APPLICATION FOR MODIFICATION ASSESSMENT REPORT

Application Number:	Mod2021/0039
Responsible Officer:	Alex Keller
Land to be developed (Address):	Lot CP SP 31058, 11 Victoria Parade MANLY NSW 2095 Lot 1 DP 77358, 9 Victoria Parade MANLY NSW 2095
Proposed Development:	Modification of Court Consent DA0220/2013 under s4.56 of the EP&A Act, granted for demolition works, construction of a mixed use development and strata subdivision
Zoning:	Manly LEP2013 - Land zoned B2 Local Centre
Development Permissible:	Yes
Existing Use Rights:	No
Consent Authority:	Northern Beaches Council
Delegation Level:	NBLPP
Land and Environment Court Action:	No
Owner:	Cecil George Koutsos Isabel Brenda Koutsos
Applicant:	Ces Koutsos
Application Lodged:	16/02/2021
Integrated Development:	Yes
Designated Development:	No
State Reporting Category:	Residential - New multi unit
Notified:	03/03/2021 to 02/04/2021
Advertised:	03/03/2021
Submissions Received:	21
Clause 4.6 Variation:	4.3 Height of buildings: ('Section 4.56' of the Act negates Clause 4.6) - variation 52.2% and 6.16 Zone B2 Gross floor areas per Cl4.4 FSR ('Clause 4.56' of the Act negates Clause 4.6) - variation 28.8%

Image: Cross section east - west and site plan showing change in floor levels (including 15 Units) and plan view of building position to side, front and rear boundaries.

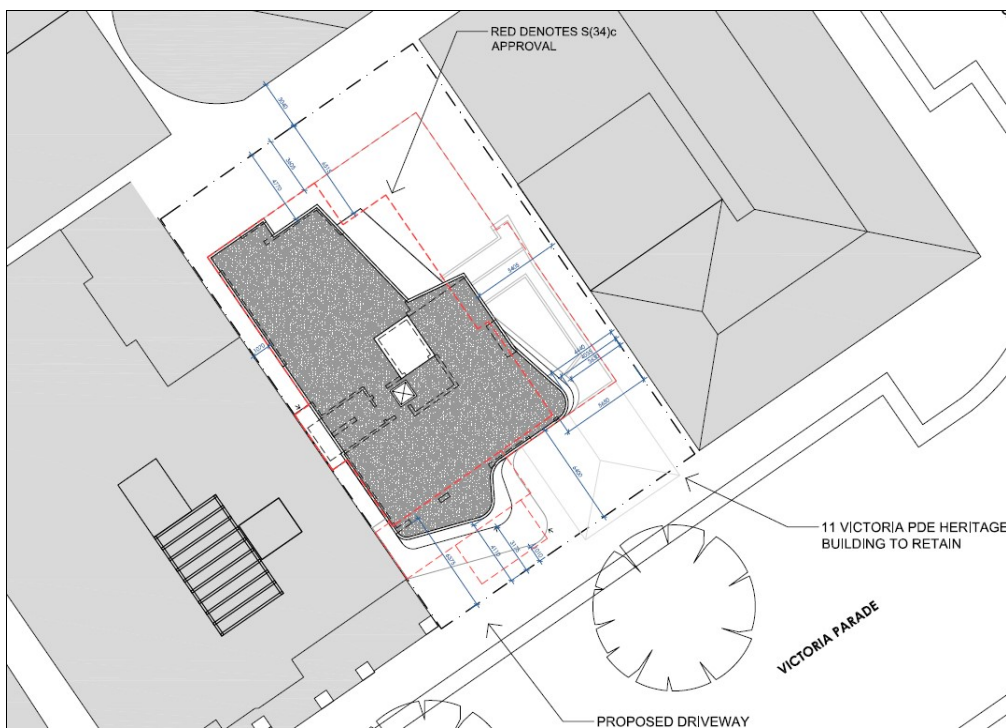
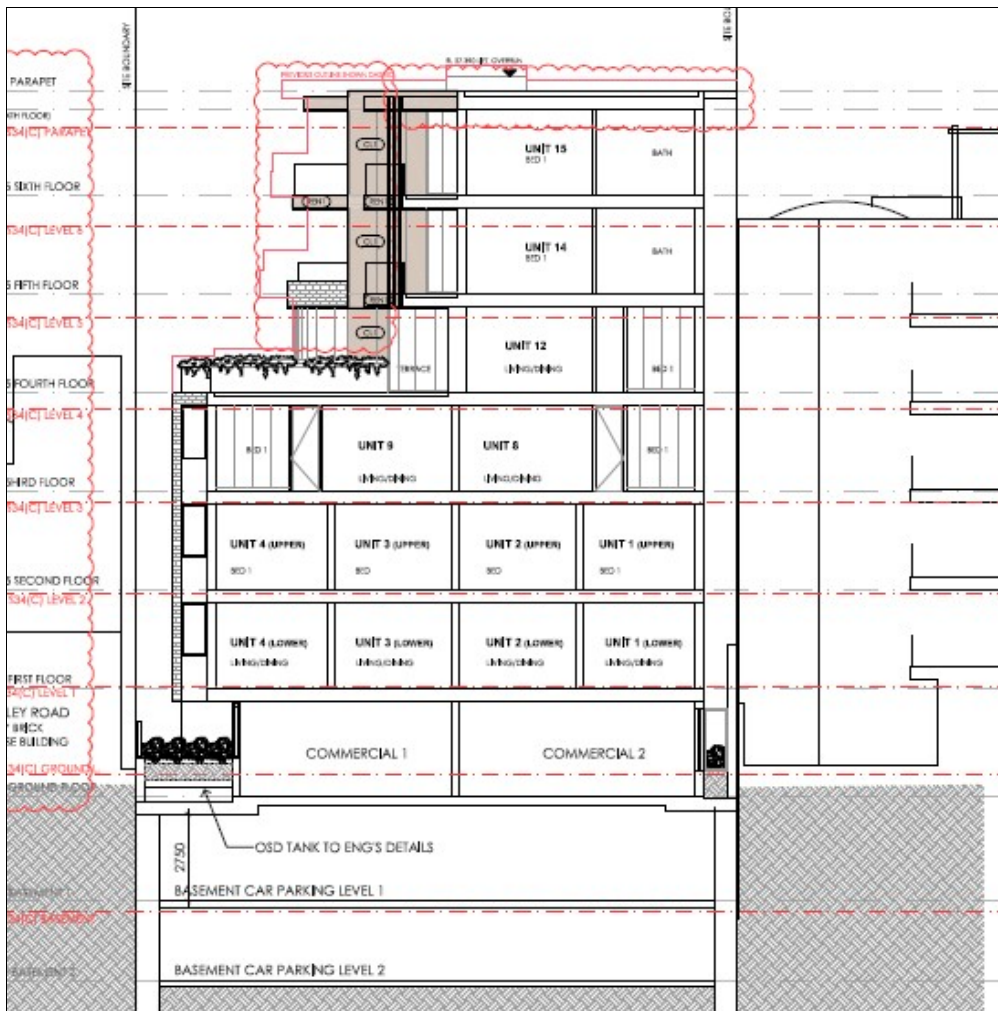
Revisions to the plans during assessment include:

1. Reduced building height by 0.35m (RL changes)
2. Reduced building envelope at SE corner to Level 5 and 6.
3. Reduced the number of units from 17 to 15 by larger full level apartment on level 5 and 6.
4. Internal layout changes due to reduce envelope (e.g. compressed width)
5. Delete raised planter at ground floor entry lobby.
6. Amend external finishes and reduced depth of slab edges.
7. New window to eastern wall of level 5 and 6.

Image: Red outline of DA22/2013 approved building shape with modification image montage and view angle across Level 4 podium.

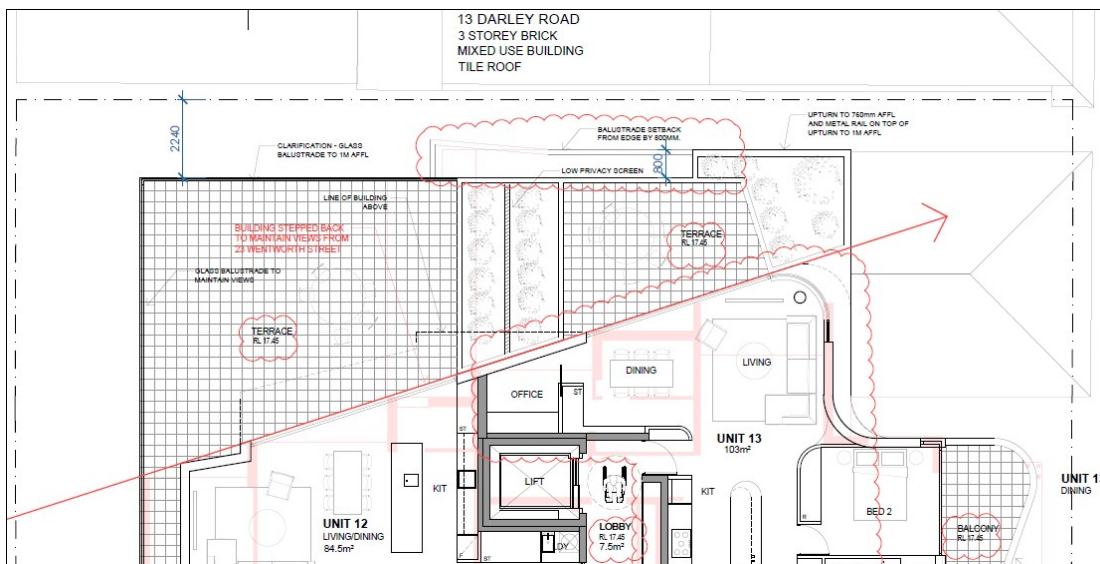
The modification is likely to alter the view impact toward St Patrick Estate due to the raised floor and balustrade elements at the podium level for the modification. In recognition of this the applicant has revised the plans to reshape the eastern balconies and marginally lower the floor levels as per the amended plans dated 21.7.2021. To further reduce view concerns for views toward St Patrick Estate it is recommend that the width of the podium terrace for Unit 12 (RL17.45) be limited, with the balustrade / terrace following the same alignment as the eastern wall for Unit 12 and 13. The resulting terrace is not more than 3.5m wide and the additional height of the balustrade (0.9m) does not overextend the view impact to the south east. While the view corridor to the south east and St Patrick Estate is highly vulnerable the modification should not unnecessarily create additional minor intrusions at standing level and would therefore have some marginal change also to a sitting position as per DA2020/2013 from RL14.07. Higher up, the view line impact to the south-east above RL 20.0 (L5 and L6, including the roof height) is consistent with DA220/2013.

Image: View montage east from roof top terrace across side boundary. The approved outline of the building already obstructs the eastward view due to approved height. Note that this roof terrace also gains views toward Manly Harbour along Victoria Parade.

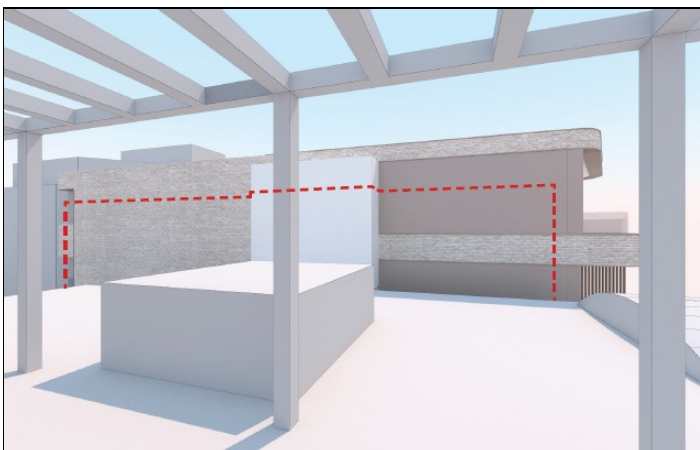
Views along from No.5-7 Victoria Parade are affected by reshaping of the front balcony element. Both standing and sitting views are affected due to the existing open side setback and open front setback

area above the existing building on the site. The approved plans for DA220/2013 have square shape balconies with thick supporting posts / frames as indicated by the dotted outline in the image below (looking eastward across the front setback and side boundary). The modification has reshaped the wall for the front bedrooms and balconies. The angled front wall creates an impact on corner windows but the revised curved balcony shape reduces the bulk of the vertical pillars to minimise that view impact along the streetscape. On balance the view impact is considered to be substantially the same without creating unreasonable impact for easterly views from No.5-7 Victoria Parade.

Image: Plan view of building and balcony outer balcony elements revised (shaded) as part modification assessment with approved building DA220/2013 outline also shown in dotted red.

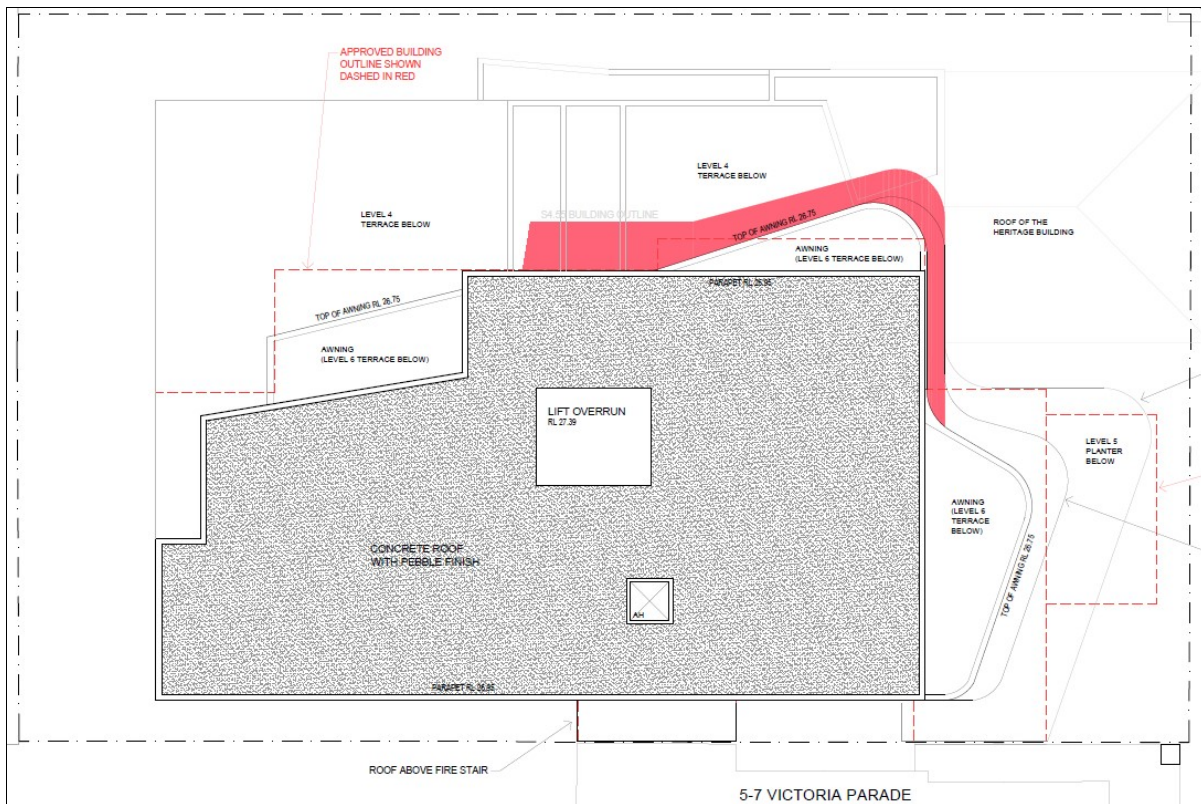
An assisting factor to the view assessment has the ability to make a comparison to the existing consent and comparison is used in context as a guideline to evaluate the views, and the level of skill applied in the modified design to addressing the need to remain substantially the same as the view impact ("control points" being outer limits of solid walls / balconies). This is demonstrated in the amended modification plans dated 21.7.20201 in the image below by comparison with the outline of the approved building under DA220/2013 and the current modification.
